ACTEWAGL

ENLARGED COTTER DAM

TECHNICAL REVIEW PANEL REPORT NO. 20 BY

15 AND 16 AUGUST 2012

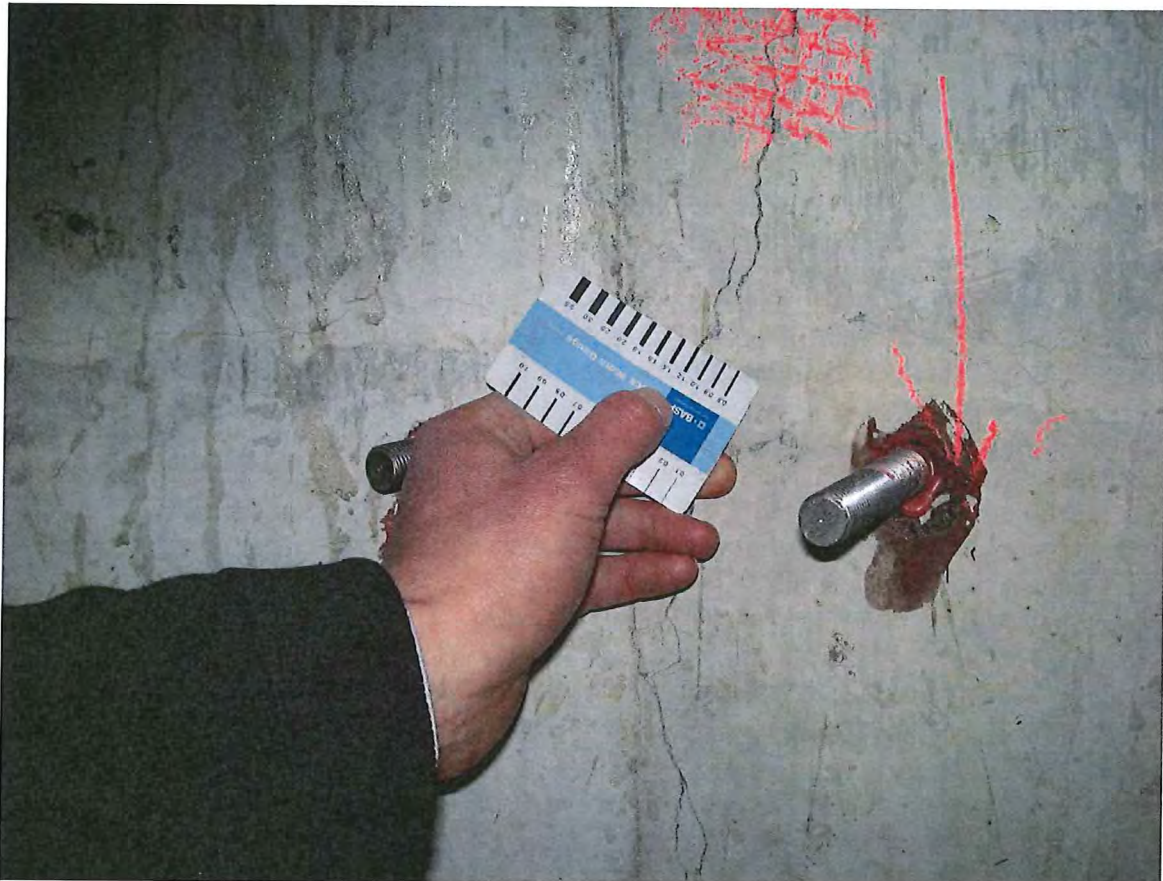
One of the inner set of cracks is shown in Photograph 5.2. In this photograph and in Photograph 5.1, one can see clearly that the cracks are not planar but do meander from the floor of the gallery to the roof. Certainly, the entrance crack deviates even more off the vertical plane near the roof of the gallery (not shown in Photograph 5.1). We would expect therefore that there is considerable shear strength along any of these cracks, in which case, the body of particular monolith should behave virtually as a monolithic concrete mass.

**CROSS-VALLEY CRACKING IN GALLERY ENTRANCE – PLAN SUPPLIED BY BWA
ON 10 AUGUST 2012**

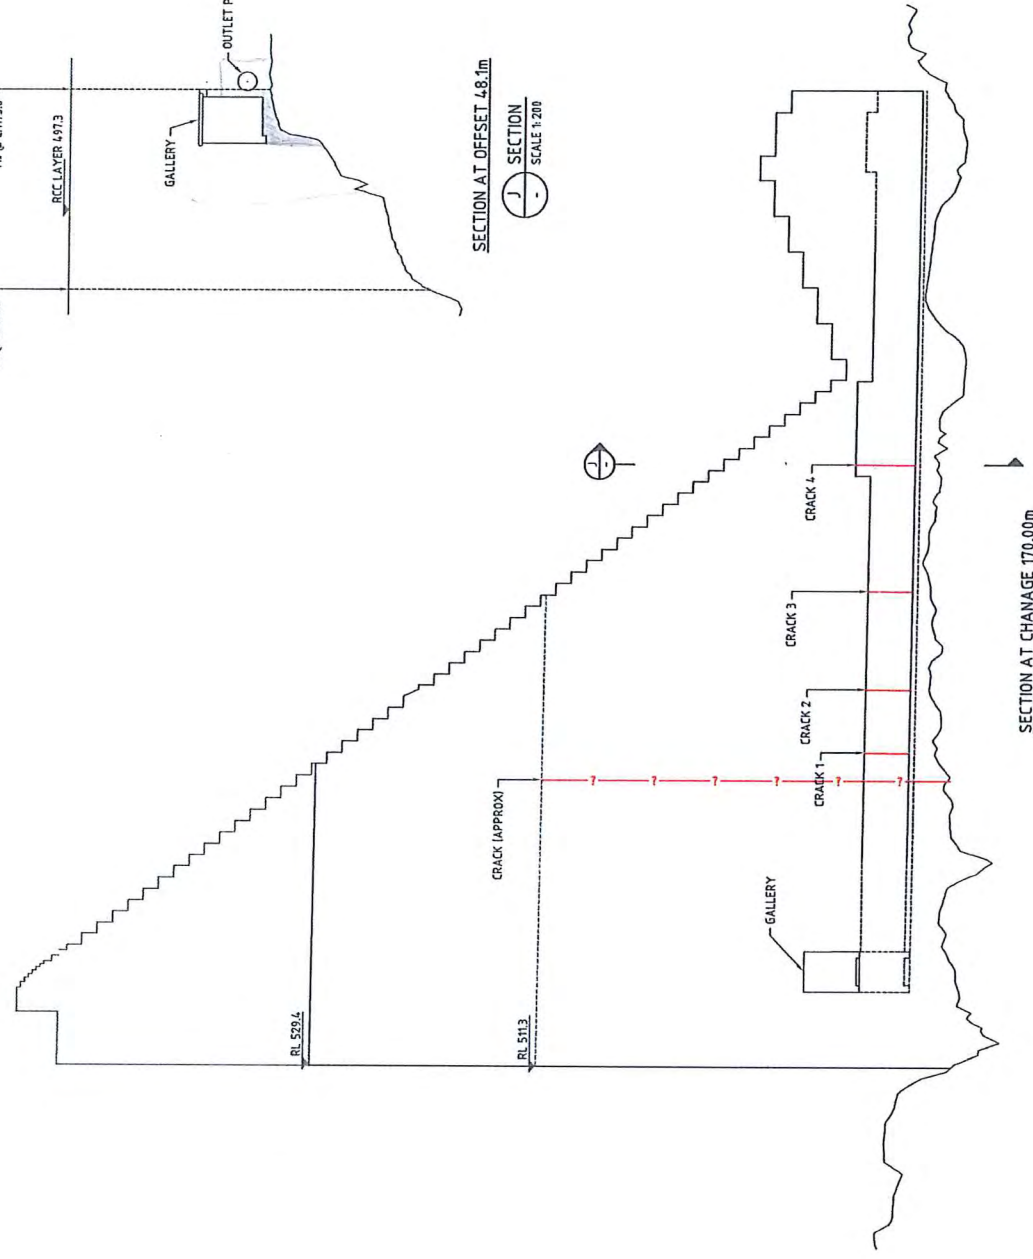
As mentioned earlier in our report and as shown in BWA’s drawing in Appendix A, cross-valley cracking has been found in the entrance gallery. With the right (uphill) side of the gallery being formed by the reinforced concrete surround for the main outlet pipe and with this side also being a monolith joint, the cracks have been picked up only on the other side of the entrance gallery. The drawing in Appendix A shows four cracks, but there are several others. These other cracks are very thin and do not seem to go from top to bottom of the gallery entrance section.

Not shown in the drawing in Appendix A is a very noticeable crack near the entrance of the gallery, under the secondary spillway channel. This crack is shown in Photograph 5.1. This crack seems to extend to the stepped surface of the secondary spillway channel, where it apparently links up with a crack in the surface of the secondary spillway channel.

We agree in broad terms with BWA's assessment of these cracks and we do support the suggestion that these cracks should be drained.
